To: Plan Holders for Improvements to the
Spirit of St. Louis Airport
St. Louis County, Missouri
MoDOT Project No. 15-113A-3
St. Louis County IFB No. 2016-05-3611-PG

Transmitted herewith is Addendum **No. 1** to the Issued for Bid Contract Documents, Specifications and Plans dated May 23, 2016 for Improvements to the Spirit of St. Louis Airport.

Schedule I: Runway 8L/26R Pavement and Lighting Rehabilitation

**ADDENDUM NO. 1
TO
CONTRACT DOCUMENTS, SPECIFICATIONS AND PLANS
FOR IMPROVEMENTS TO THE
SPIRIT OF ST. LOUIS AIRPORT
ST. LOUIS COUNTY, MISSOURI
MODOT PROJECT NO. 15-113A-3
ST. LOUIS COUNTY IFB NO. 2016-05-3611-PG**

DEMOLITION PLAN
STA. 87+15 TO STA. 93+65
RUNWAY 8L / 26R

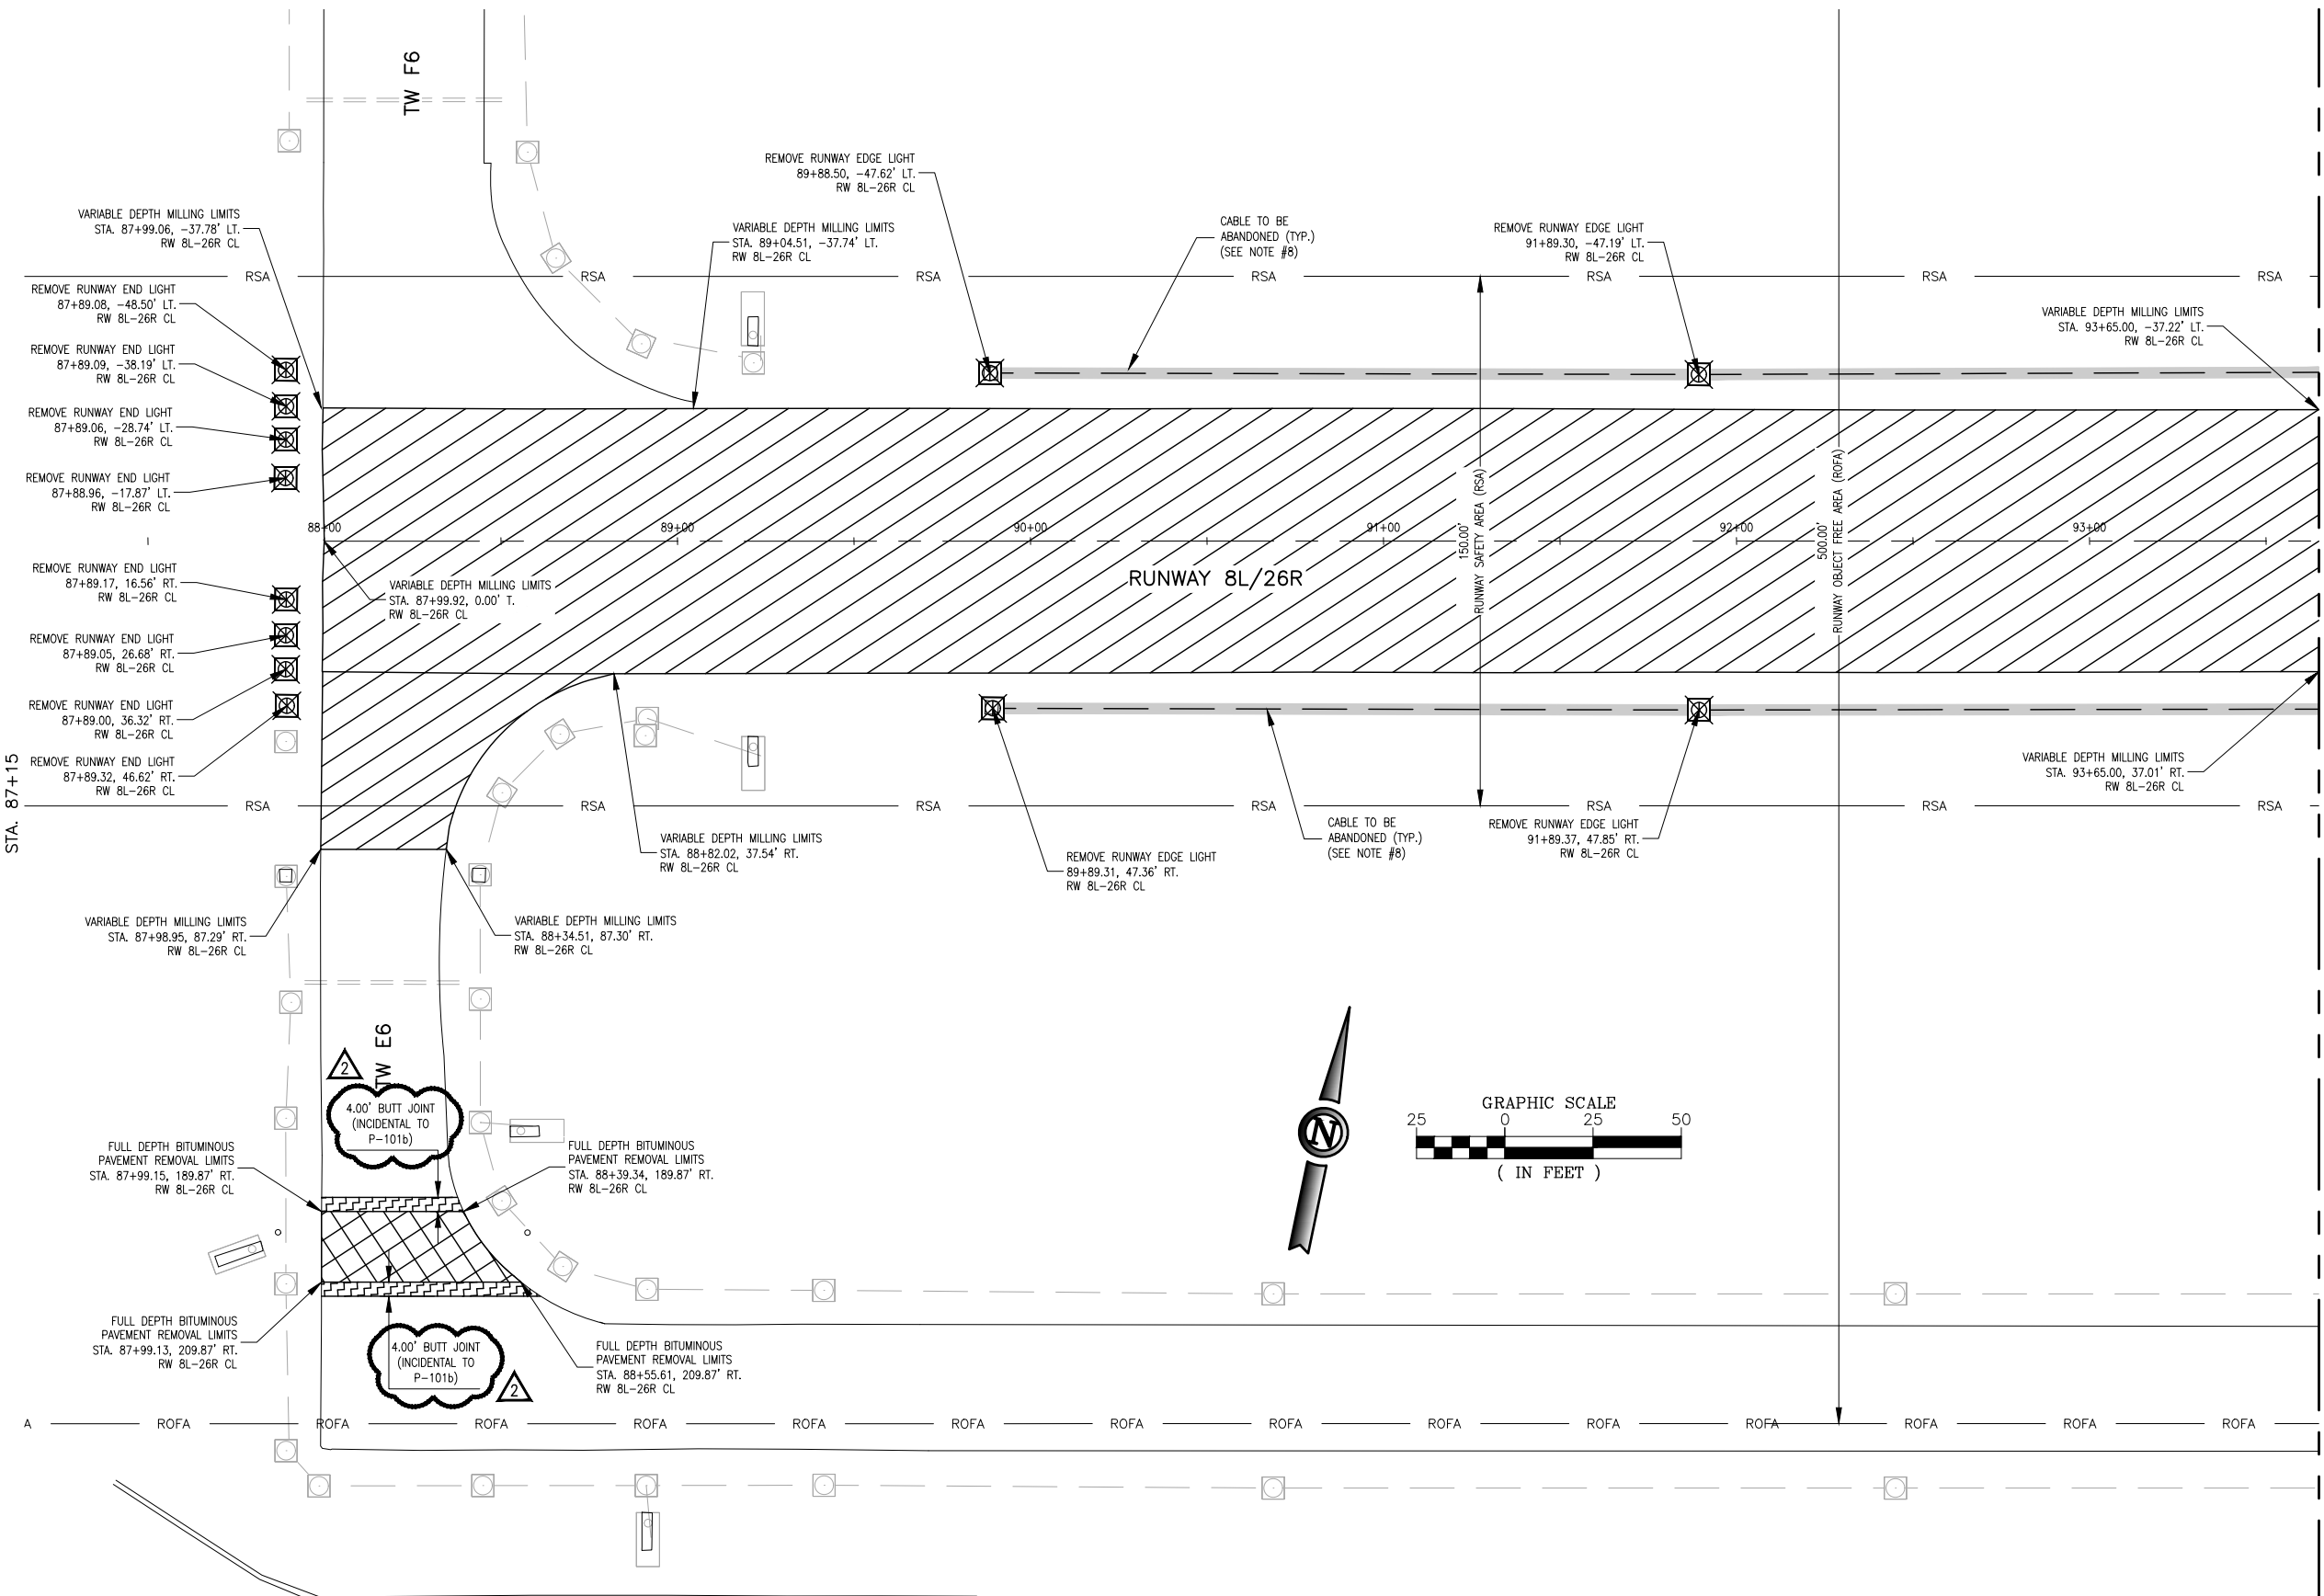
c. C100 (Sheet 12) Demolition Plan

Add "**(INCIDENTAL TO P-101b)**" to the "4.00' BUTT JOINT" labels on TW E6.

DEMOLITION LEGEND,

Add "**(P-101a)**" after "ASPHALT CRACK FILLING AND VARIABLE DEPTH MILLING".

Add "**(P-101b)**" after "FULL DEPTH ASPHALT REMOVAL".

Add "**(INCIDENTAL TO FULL DEPTH ASPHALT REMOVAL P-101b)**" after "BITUMINOUS MILLING/BUTT JOINT".

1
E201
AIRFIELD LIGHTING VAULT PLAN
N.T.S.

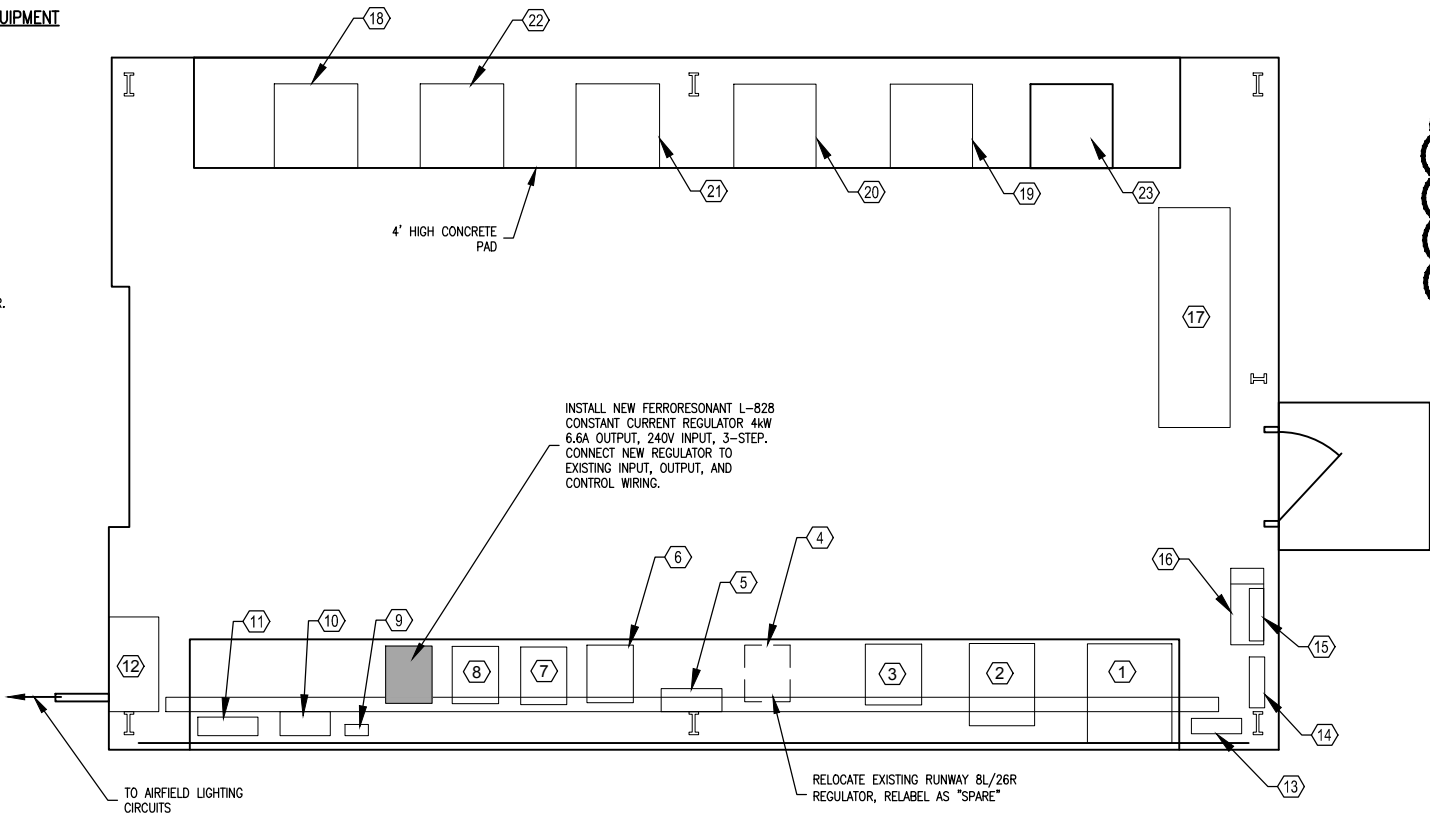
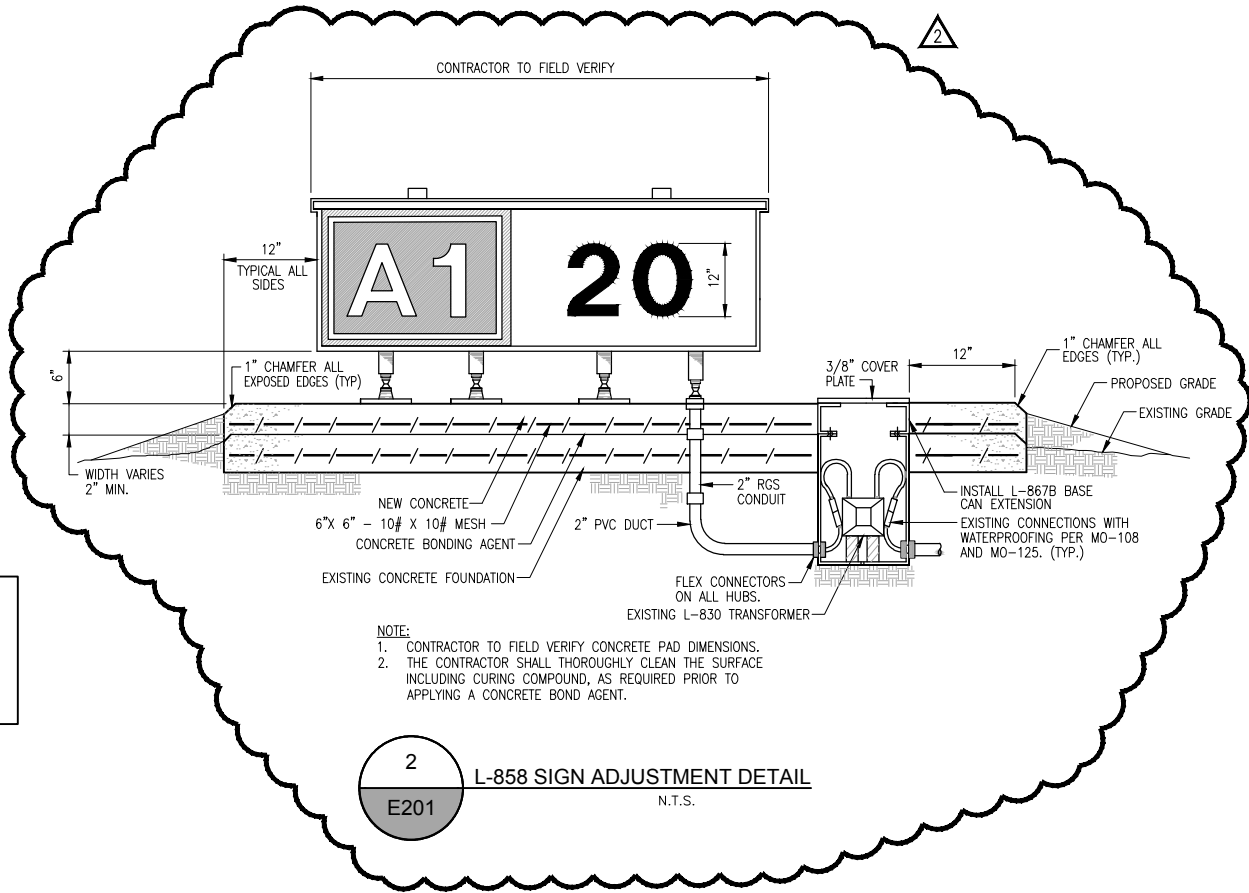
Answer: See Sheet E200 for the two details that describe the location of the proposed counterpoise. For counterpoise to be installed adjacent to pavement, reference Detail 1 on Sheet E200 – TRENCH (DEB) PARALLEL TO PAVEMENT DETAIL. For counterpoise to be installed not adjacent to pavement (as in the case of the electrical homerun), reference Detail 2 on Sheet E200 – TRENCH (DEB) DETAIL. At the location where the contractor is to install new unit duct through the existing 4" ducts, no new counterpoise will be installed at these locations.
